Stoke Golding, Hinckley
Flood Risk Assessment
June 2026

Report Ref: 29782-FLD-0101 Rev A

- 1.5 Revision A of this Flood Risk Assessment (FRA) has been produced to accord with comments from the LLFA on planning application 25/01004/FUL, dated 21/11/2025, as part of their role as statutory consultee on major planning applications to HBBC under the Flood and Water Management Act 2010.

SCALE H-1:500 V-1:100

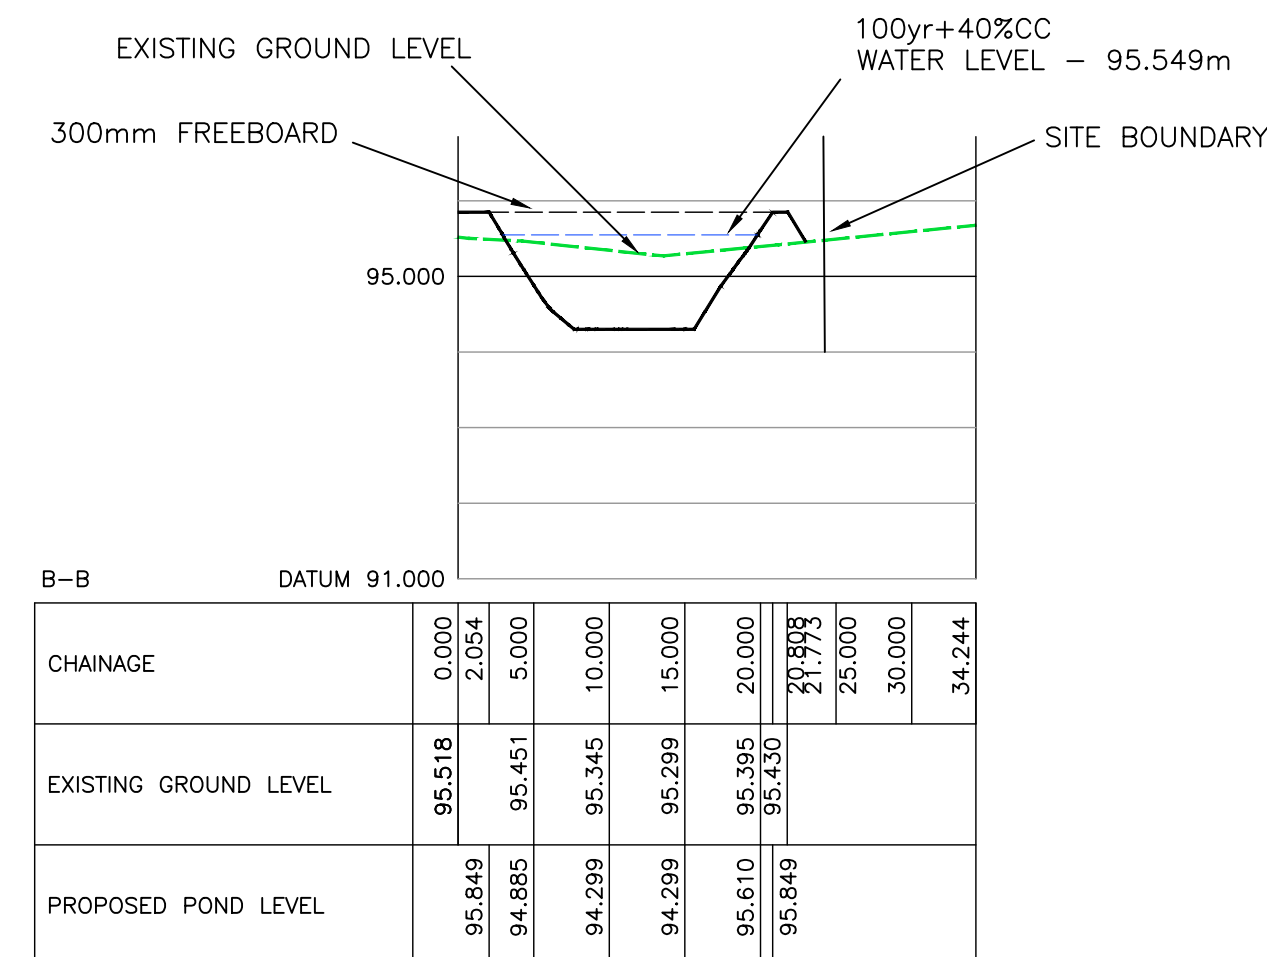
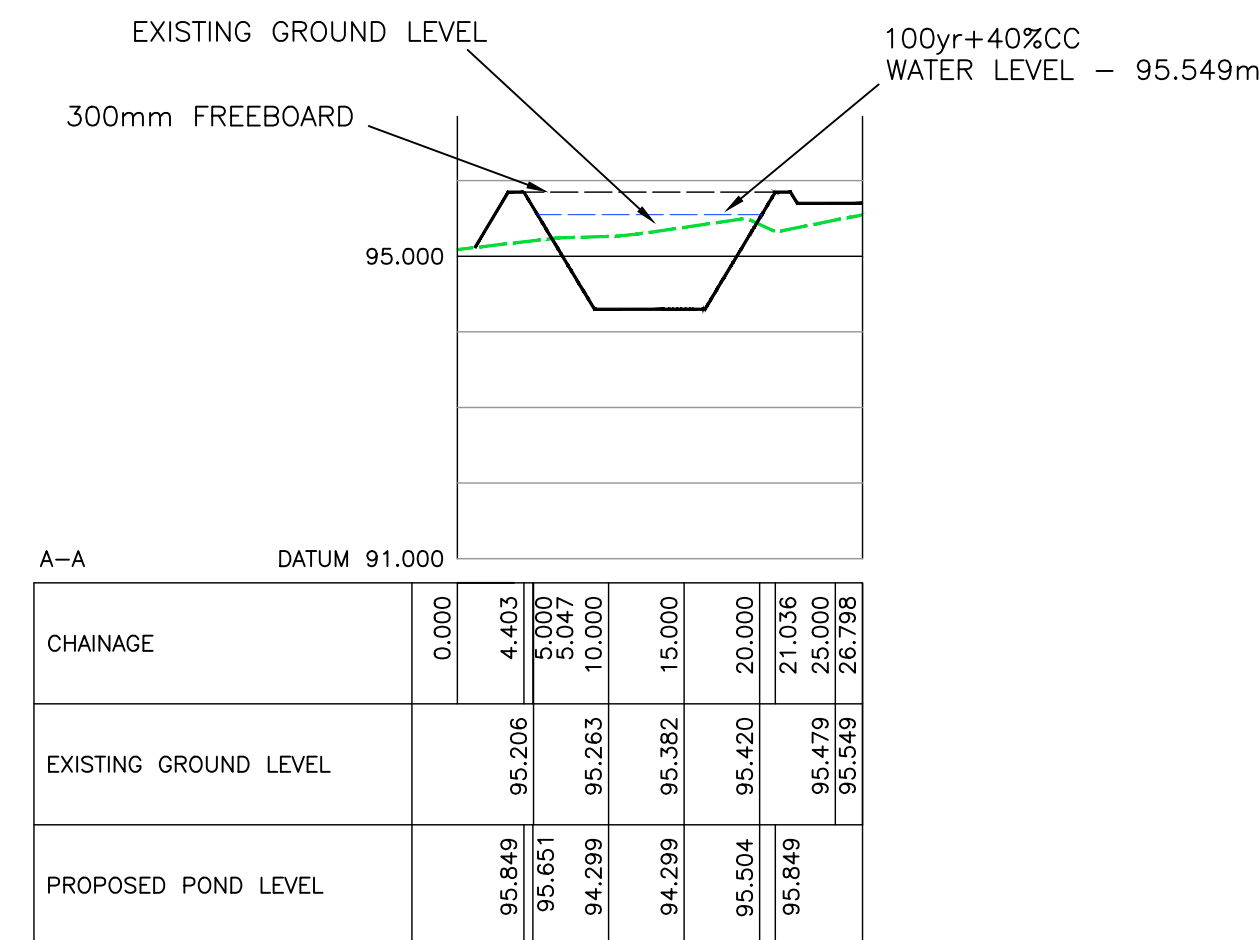
- *Provide a cross section of the proposed basin and evidence that suitable space is allowed for maintenance access by the third-party contractor.*

- *Details on how safety concerns around the proposed basin will be mitigated.*

- *Amend layout to allow for a suitable easement to any surface water drainage assets located along the east boundary of the site.*

A cross section of the proposed basin is now available in **Appendix G**, as requested.

A post and rail fence is now proposed around the attenuation basin and shown in the drainage strategy plan in **Appendix G**.

Sewer easements are shown in the drainage strategy plan in **Appendix G**.
